WEST BOUNTIFUL PLANNING COMMISSION

MEMORANDUM

RE: DelNoble Subdivision – Preliminary Plat Subdivision Application

City Engineer and Staff Review Comments

C400
SITE PLAN

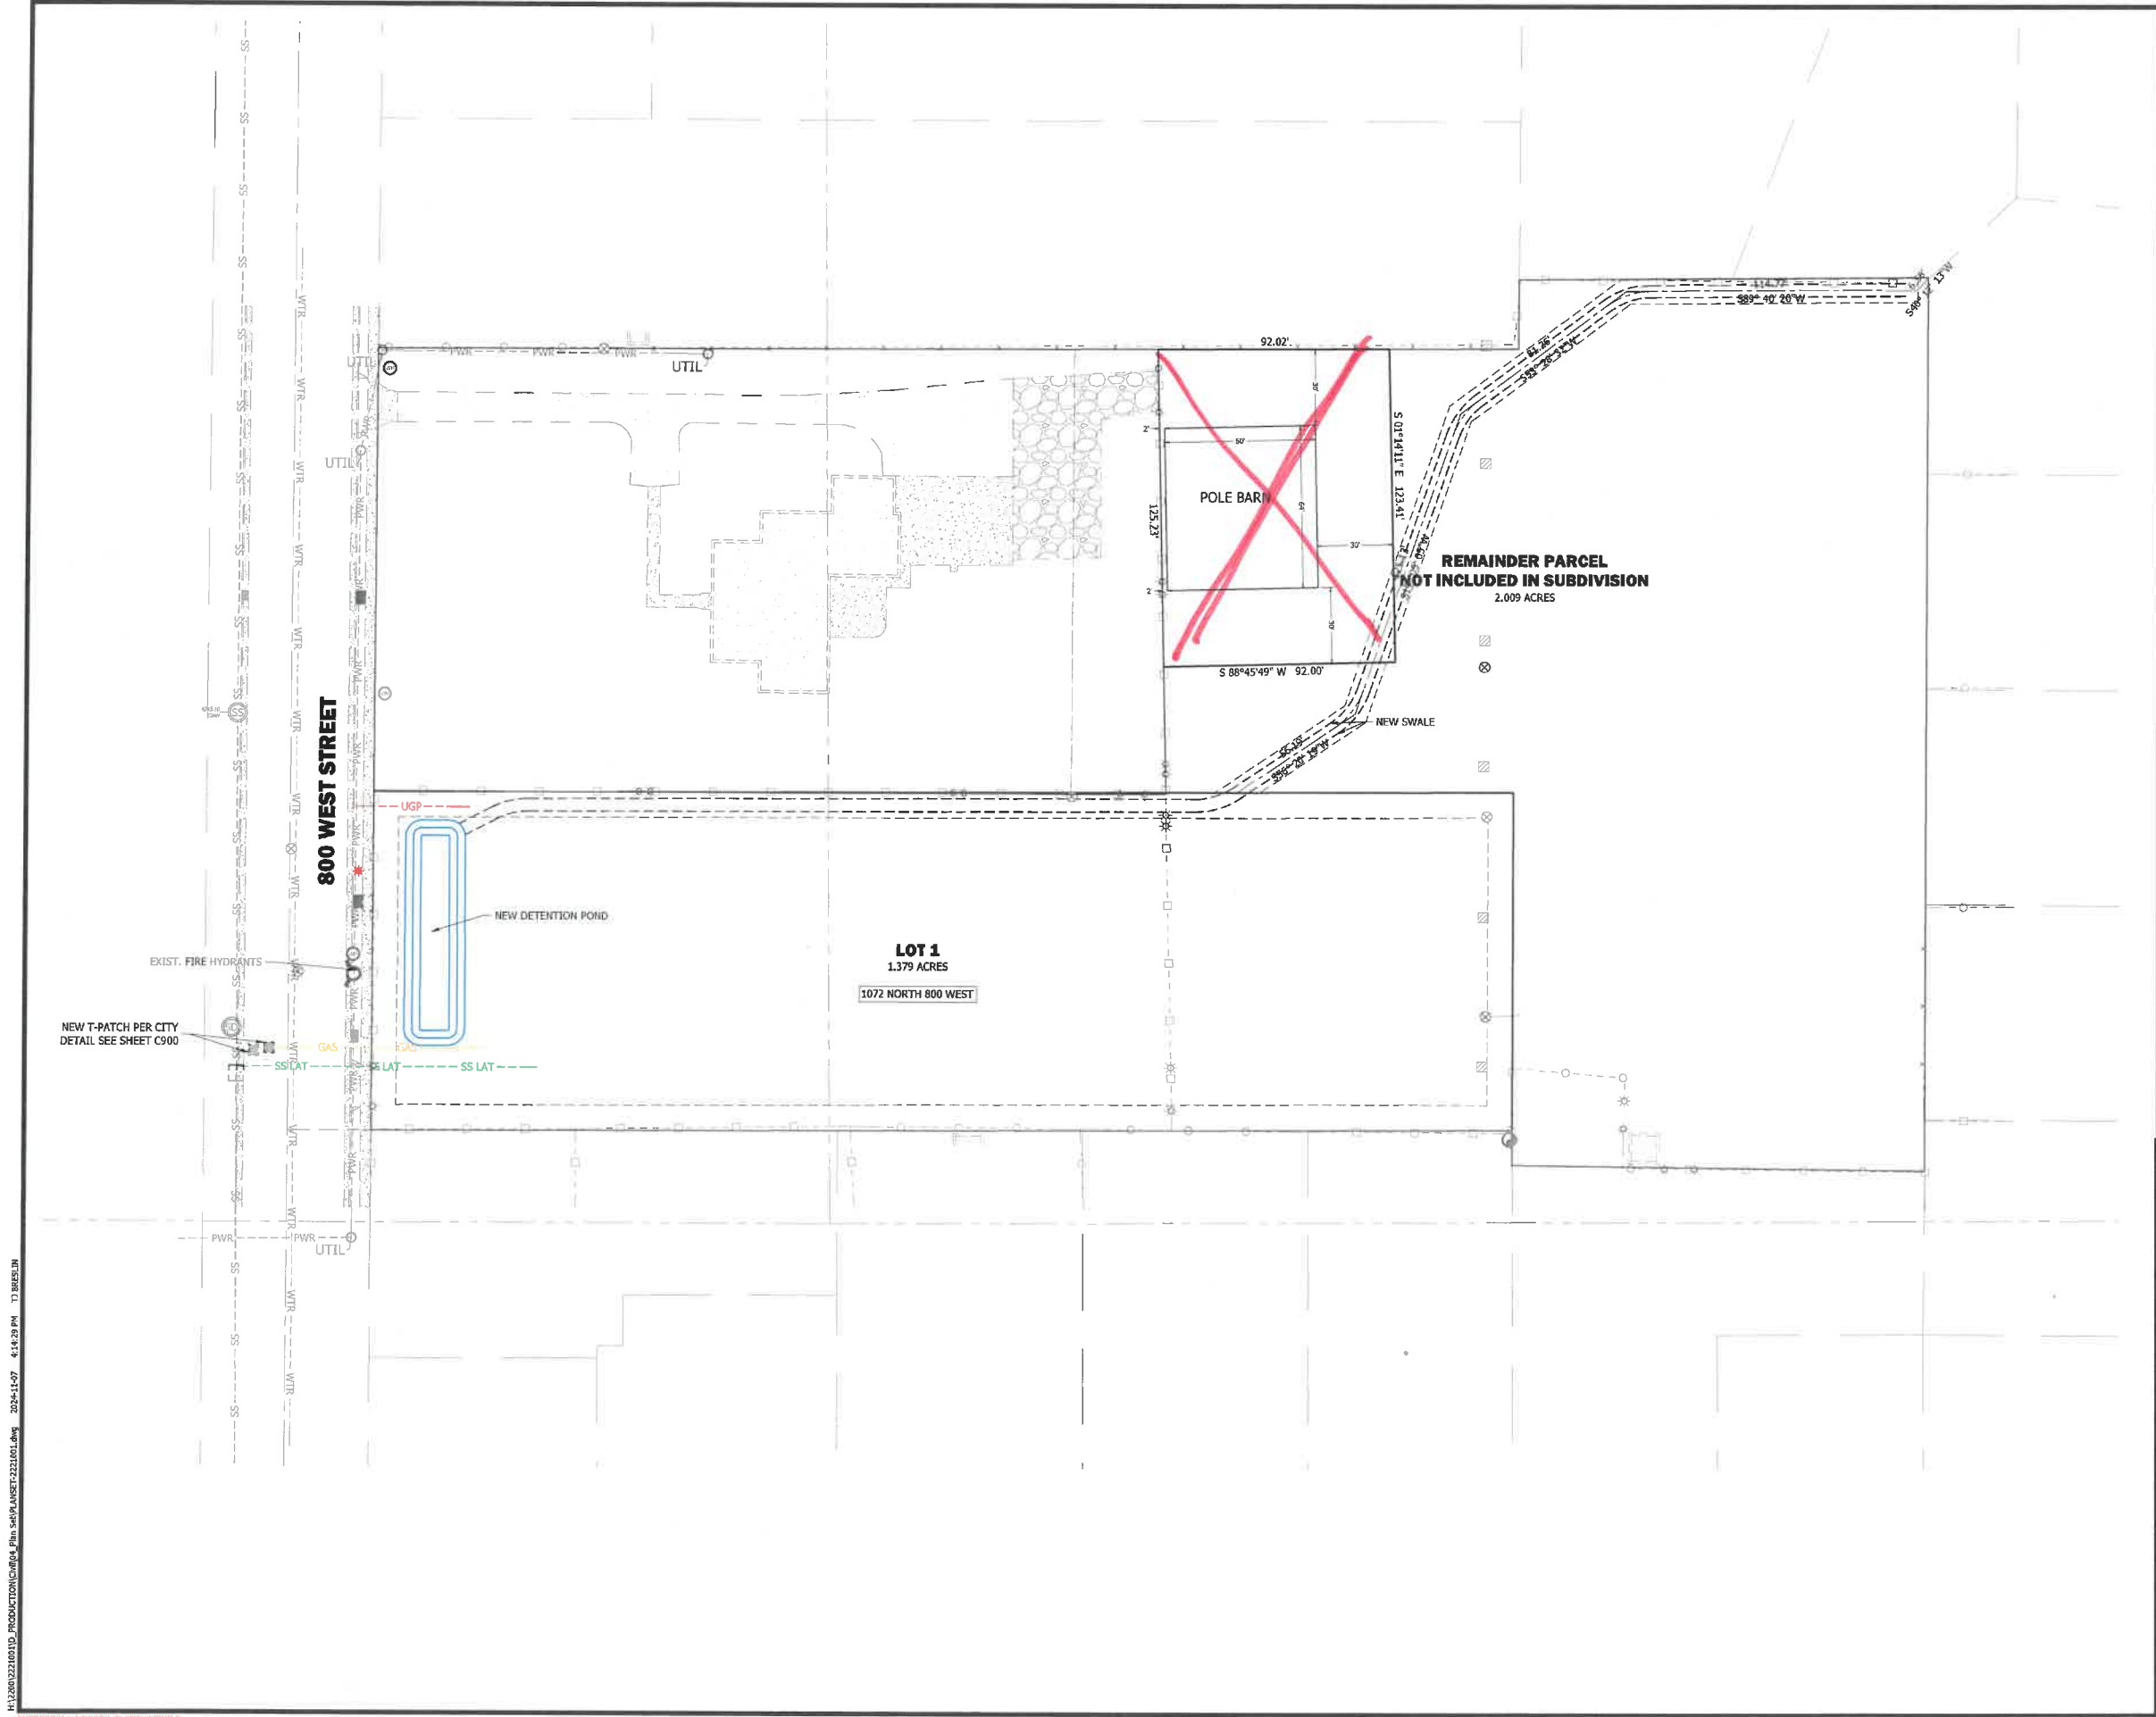
12. Drainage from the proposed development cannot flow onto adjacent properties without written agreements.
 - i. Indicate where the drainage from the NW corner of the remainder parcel will flow too.
 - ii. If it is designed to flow onto an adjacent parcel (06-014-0100 or 06-014-0039) with no existing PUE & DE than an agreement needs to be provided for review and approval.
13. Indicate that the connection to the existing catch basin will need to be core drilled and patched with non-shrink grout.
14. Provide more detail on crossing the sidewalk with the new out fall pipe from the detention/retention pond.
 - i. How much sidewalk is to be damaged and replaced.
 - ii. Add a note on the drawings requiring all new sidewalk to be six inches thick on a minimum of six inches base coarse.

15. Provide soil survey data and/or percolation test for predicting the infiltration rate used in the retention calculations provide.
 - a. At a minimum provide information from the US Geological Soil Study for expected soil type and infiltration rate at the site.
 - b. Verify the ground water table depth relative to the site elevations and confirm that groundwater will not interfere with infiltration from retention and storage for retention and detention.

REVISIONS	
SDSD COMMENTS/REVISION COMMENTS	10/25/24
UPDATED DRAINAGE CALC	11/7/2024
DRAWN: JH	2024-9-10
APPROVED: TJB	2024-11-7
PROJECT #:	2221001
PLANSET-2221001.dwg	
C600	
UTILITY PLAN

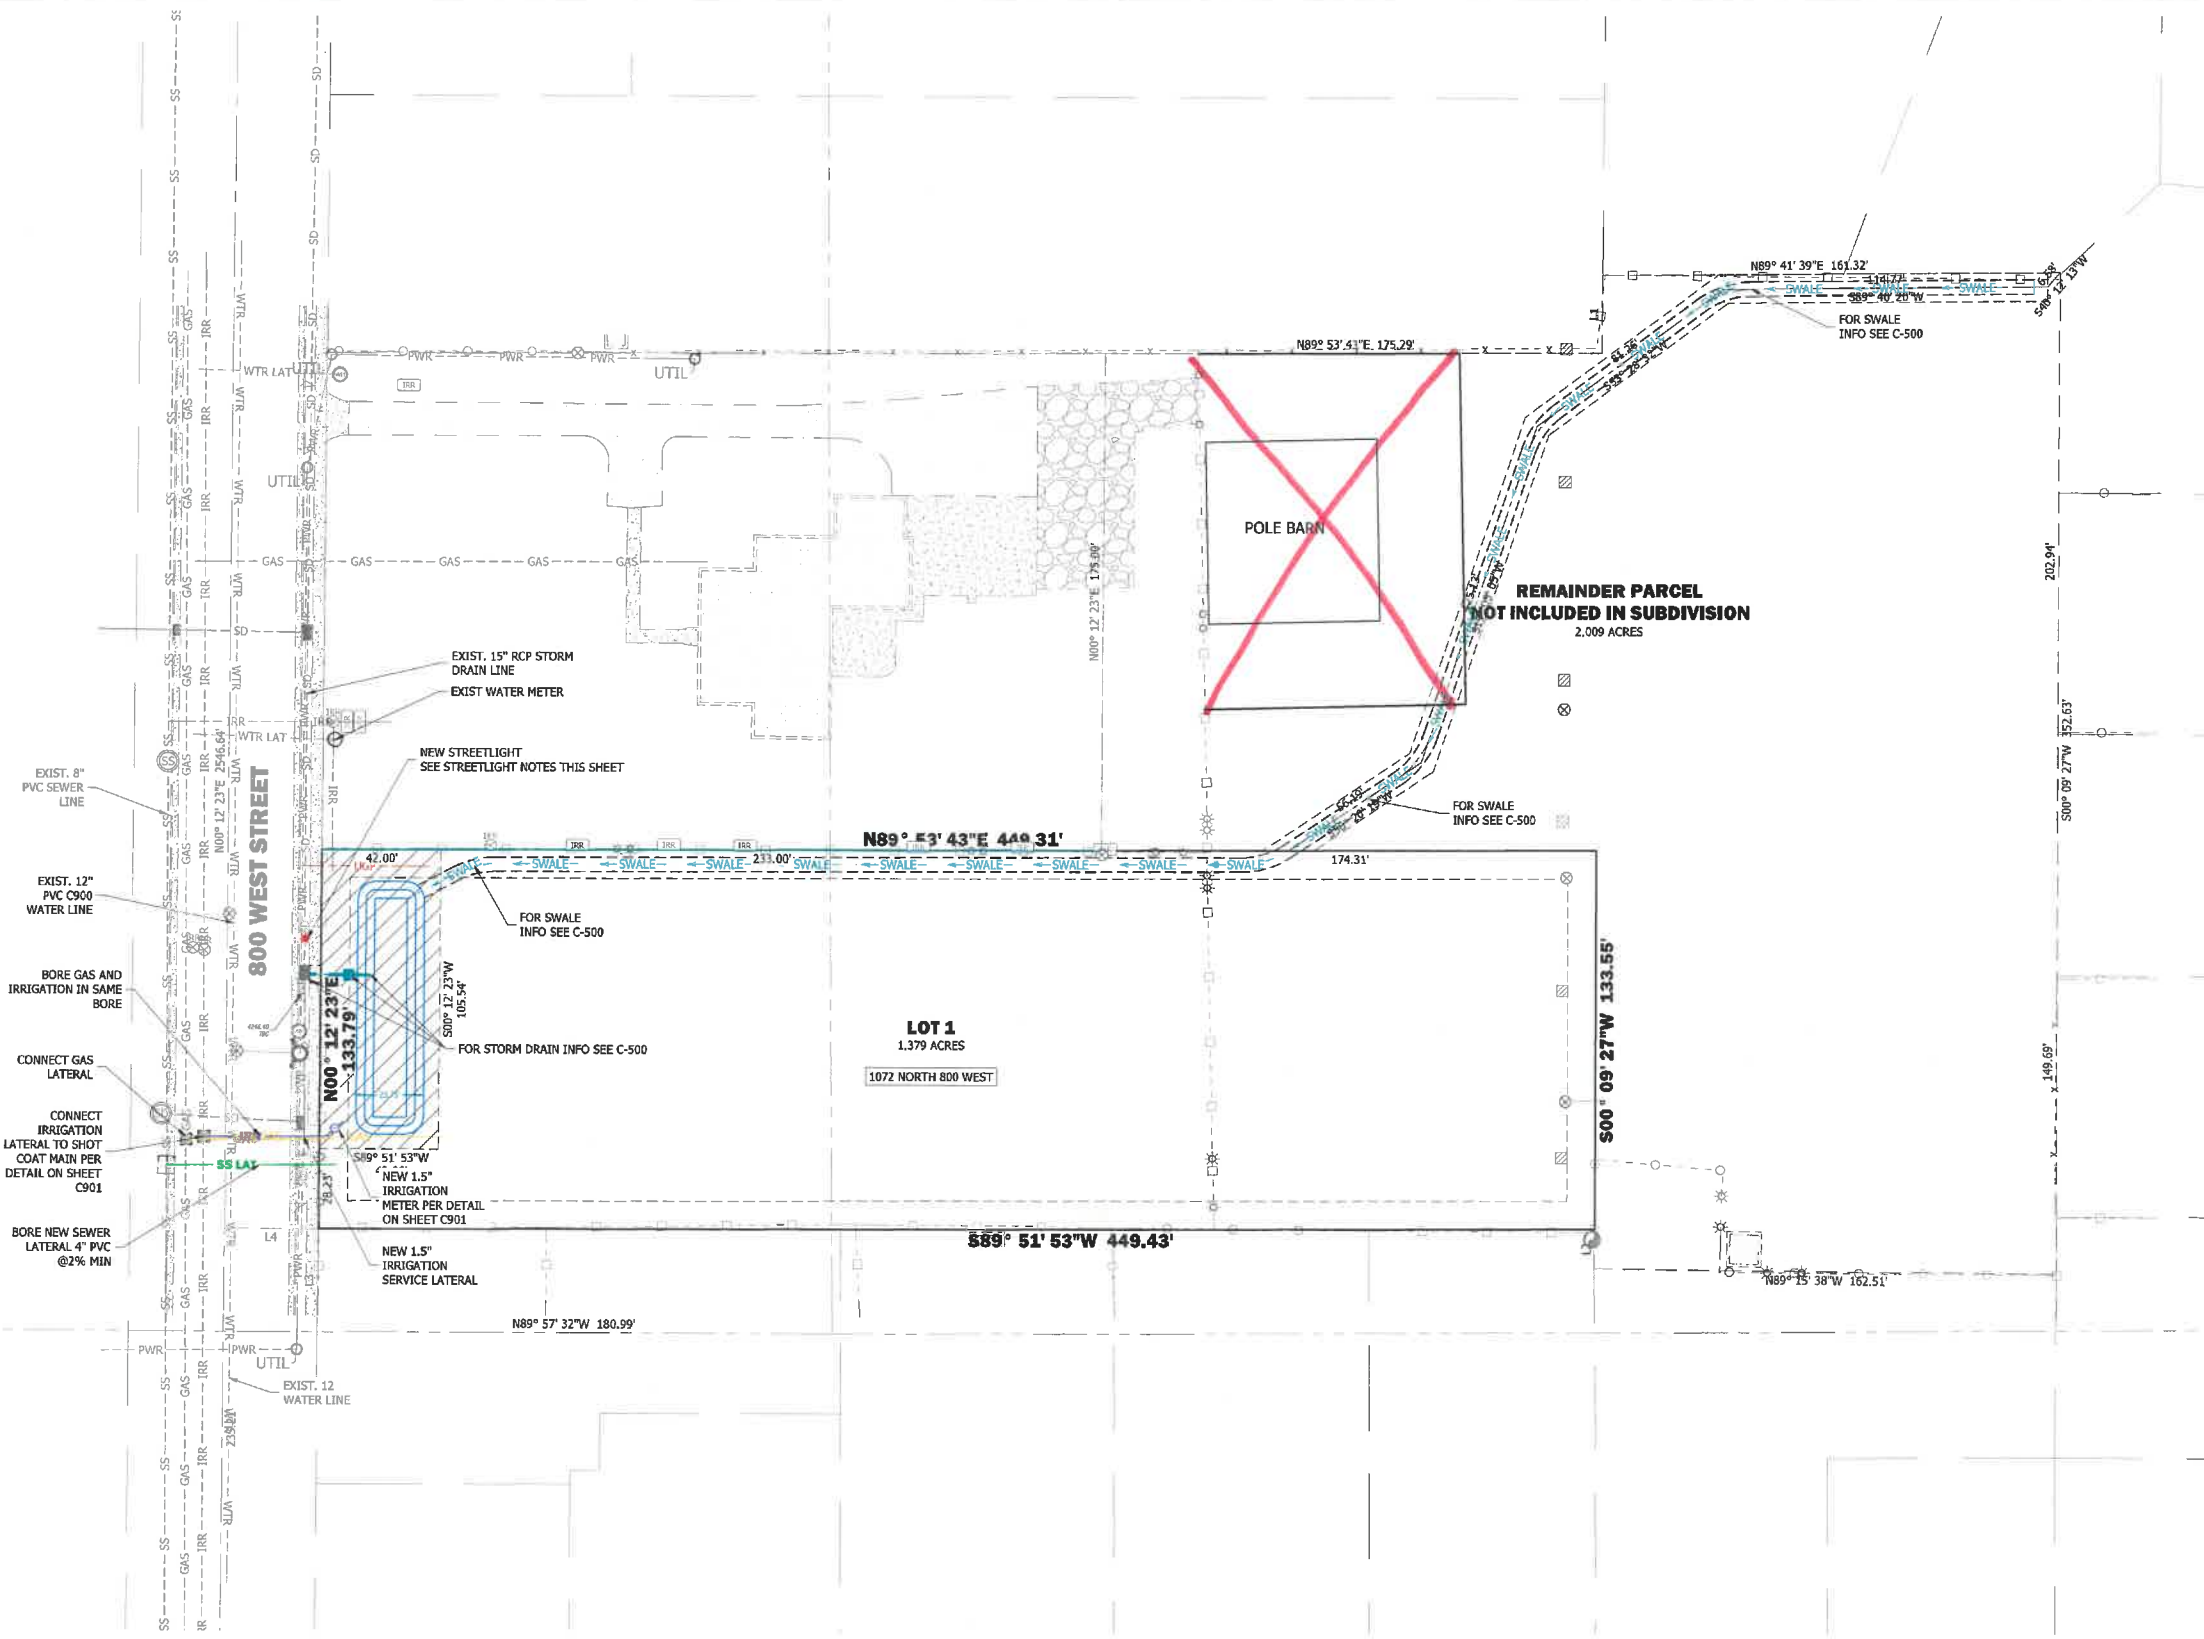
3. Provide written communication from the following utilities showing the plans have been reviewed and approved. I have will serve letters from both, but I still need approval of the design of utilities for the following.

- a. Dominion Energy (gas)
4. Add pipe size and type to all existing and proposed utilities.
 - a. Indicate new gas lateral pipe size and type.
5. Indicate the proposed depth of cover on all proposed lateral crossings into 800 west street.

6. Add a label to the existing culinary water meter to proposed lot 1 on sheet C-600
7. Provide the elevation of existing top back of curb (TBC) near the middle of the 134.05 feet of frontage the project has on 800 west.

- a. For comparison to drainage plan elevations, FF, and contours.
 - b. Add a note to the plat requiring all finished floor elevations to be 12 inches above TBC.

8. Combine the two bore pits in 800 west existing asphalt into one bore pit and make the one bore pit as small as possible.
9. Add note indicating backfill in the bore pits shall be flowable fill up to bottom of new asphalt.

10. Add indicating patch/New asphalt depth is six inches minimum thickness.
11. Update the label on sheet C-600 (and other sheets if applicable) to indicate six-foot-wide park strip existing.
